Addendum No. 1, June 4, 2026

Re: East Stadium Food Truck Park
Tennessee Technological University
TTU Project No. 26-075

JOB NO.	2346T
ISSUE DATE	06/02/26
SHEET TITLE	SITE PLAN AND DETAILS
DRAWN	KTC
REVIEW	KAC
	A1.1

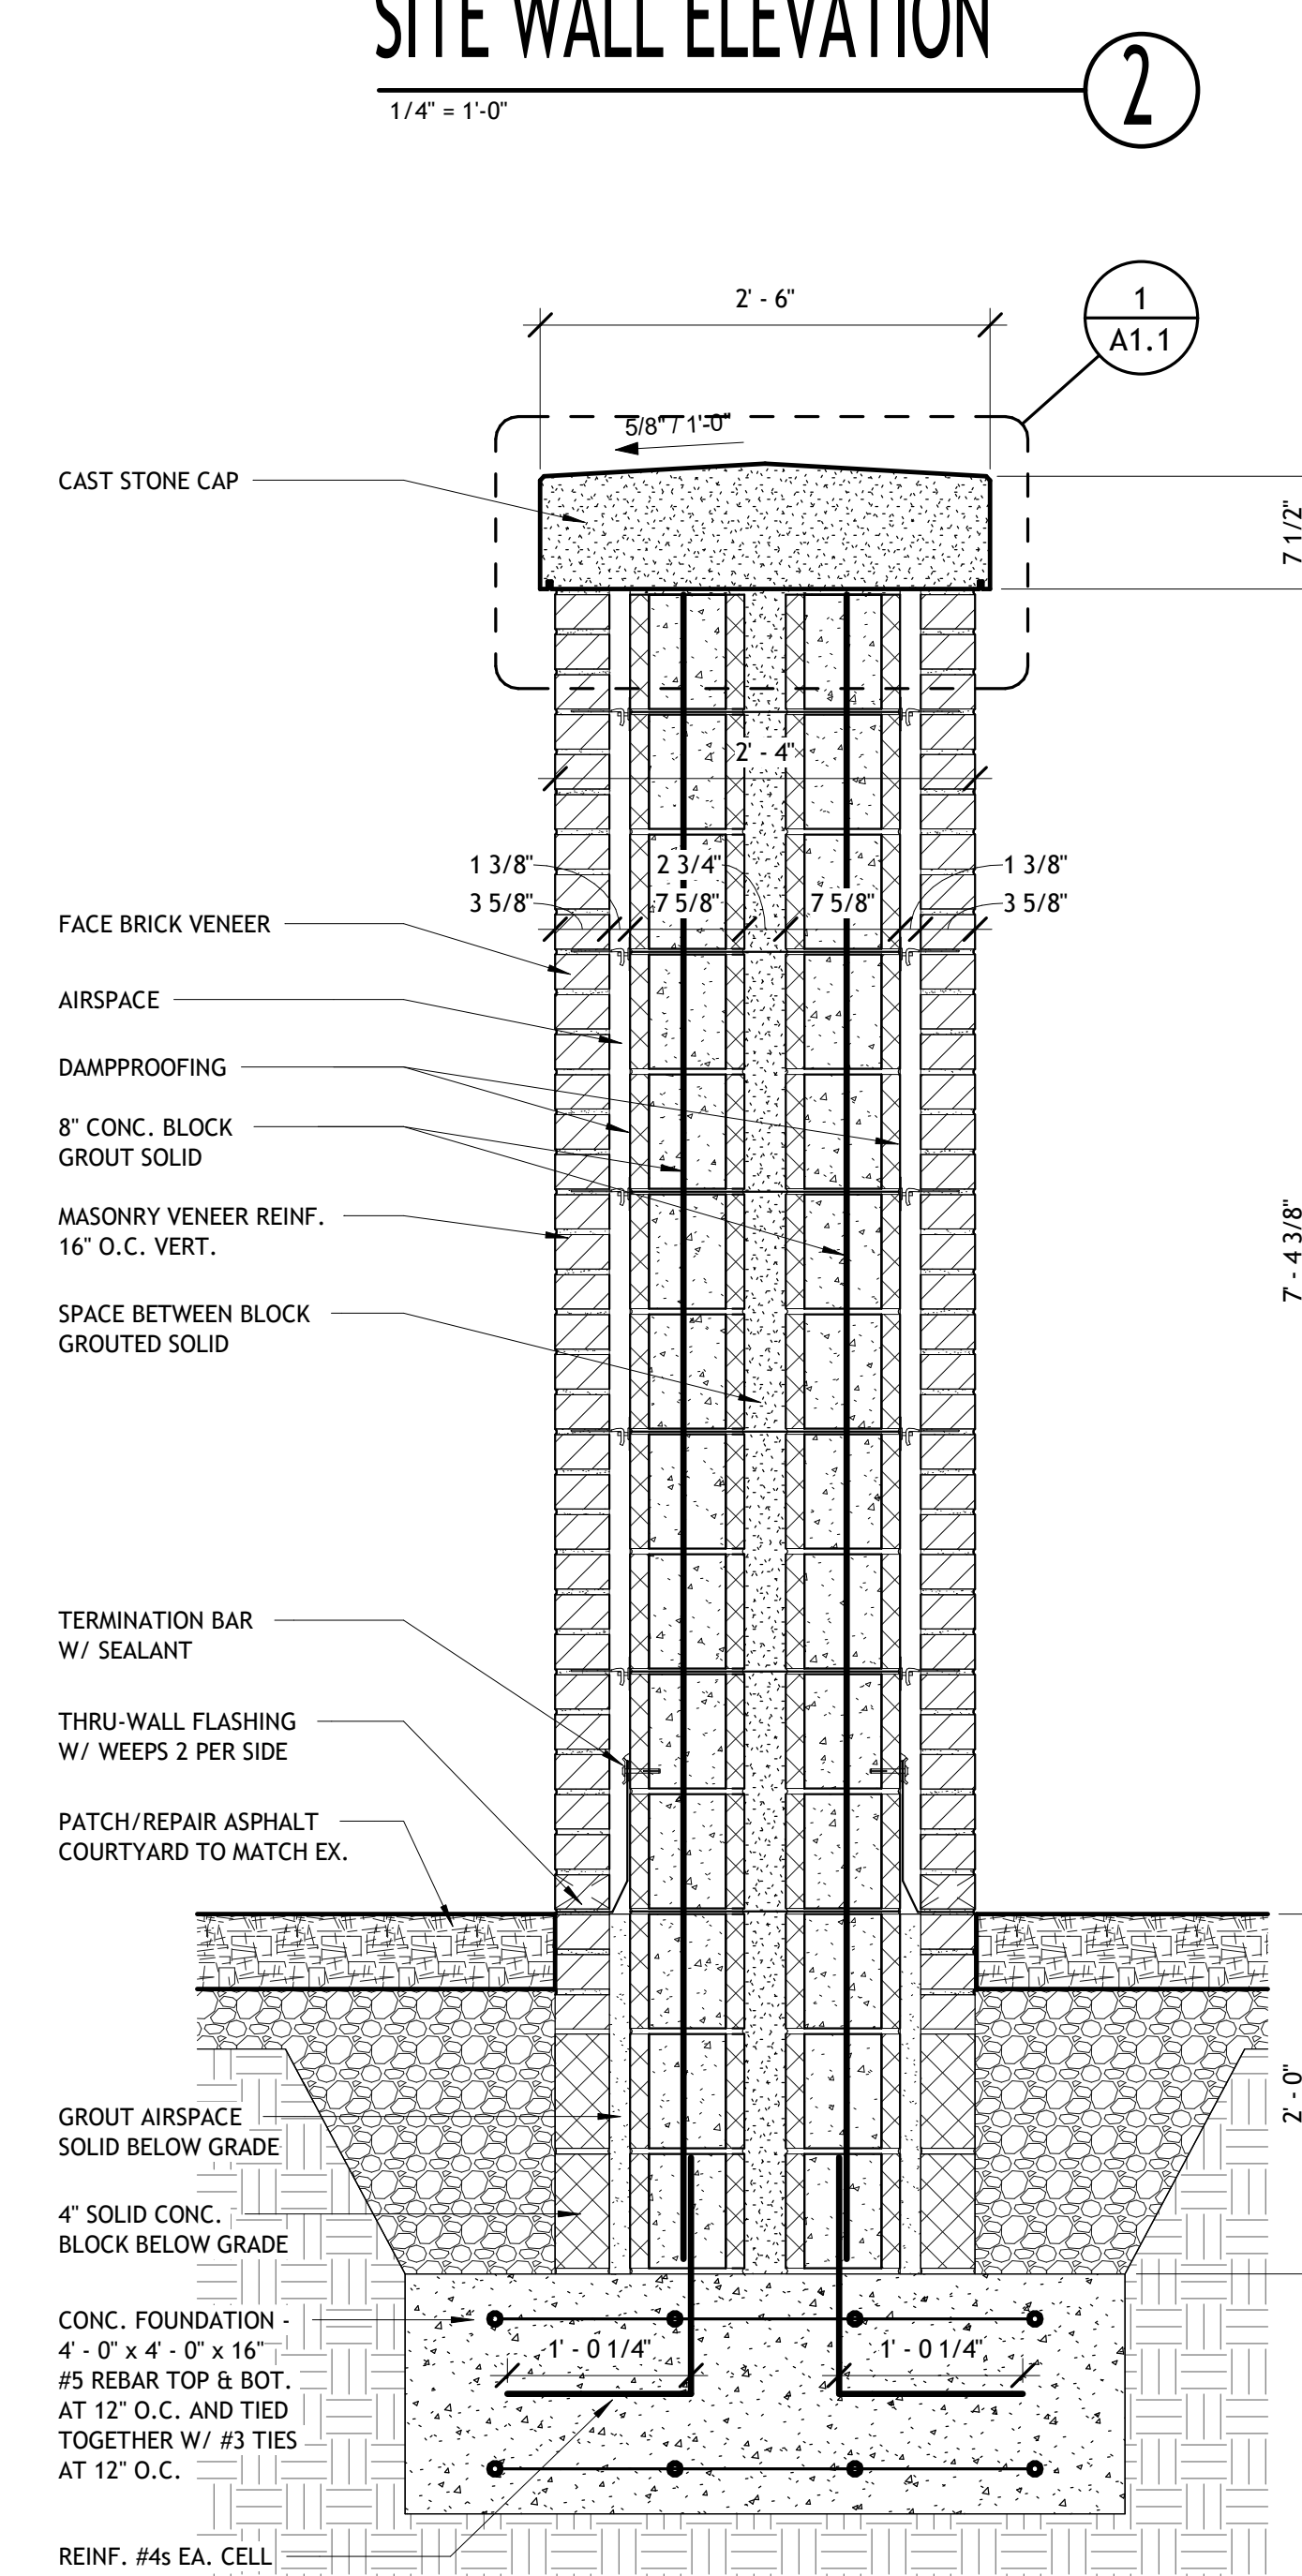
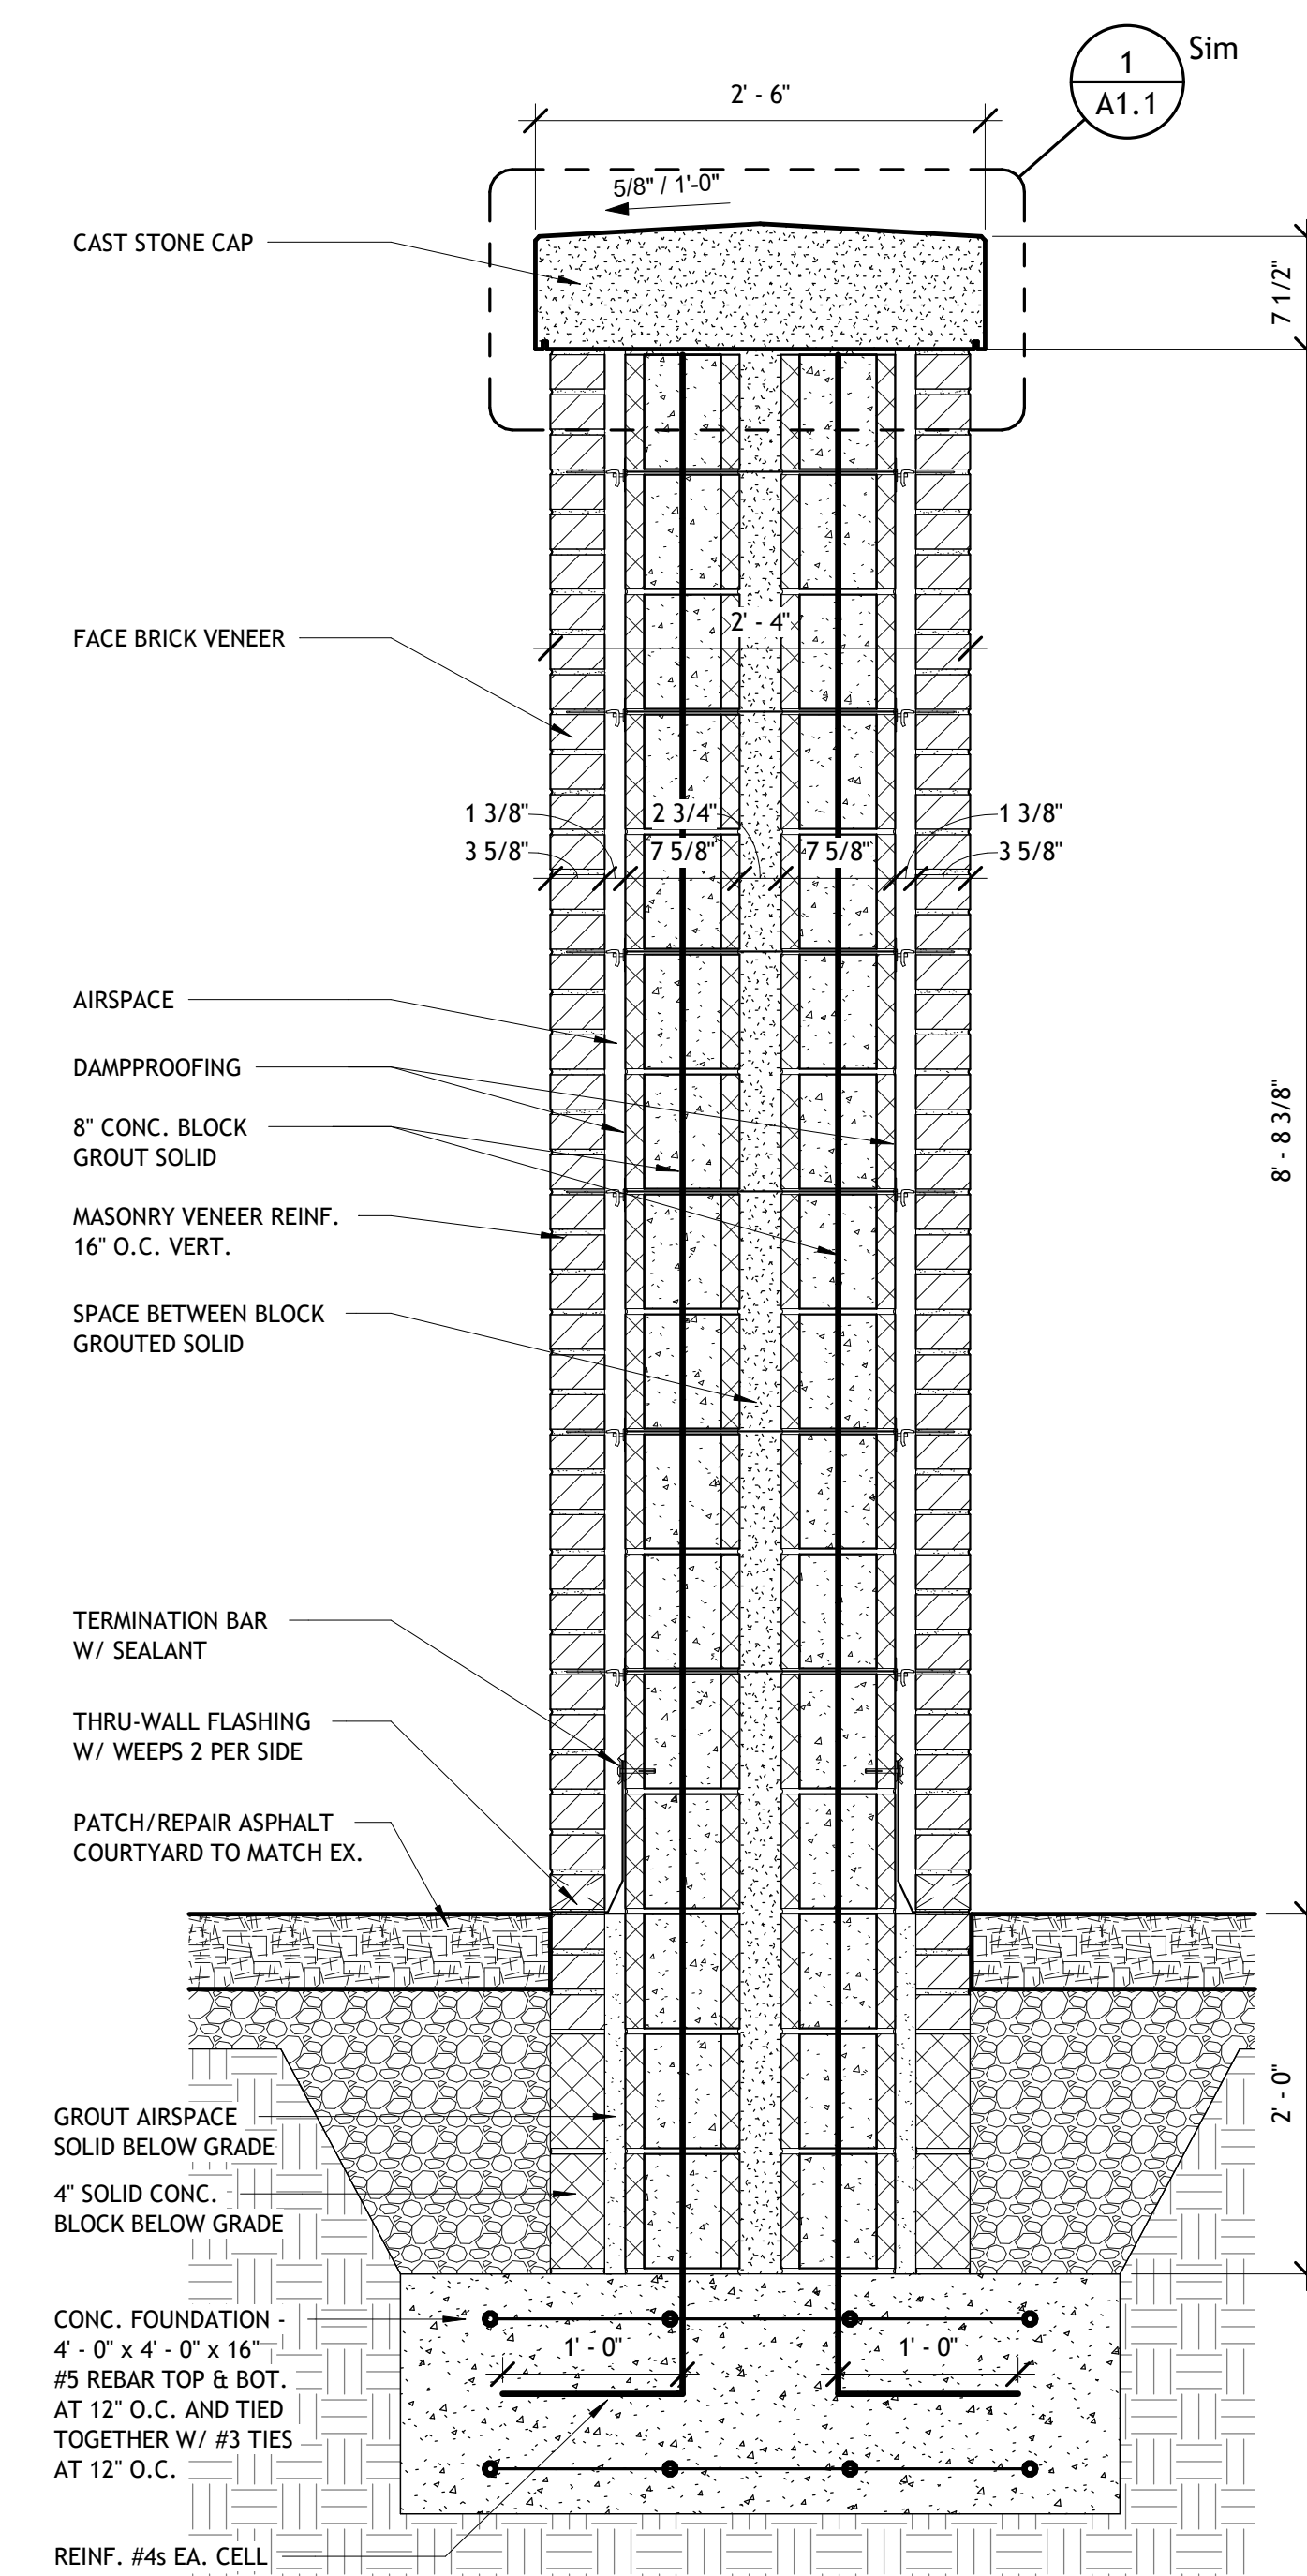
- 1) Refer to Drawings A1.1 & A1.2. Replace with attached Drawings A1.1 & A1.2, Revised Date 6/4/26. Changes reflect a revised layout for the entry gates.
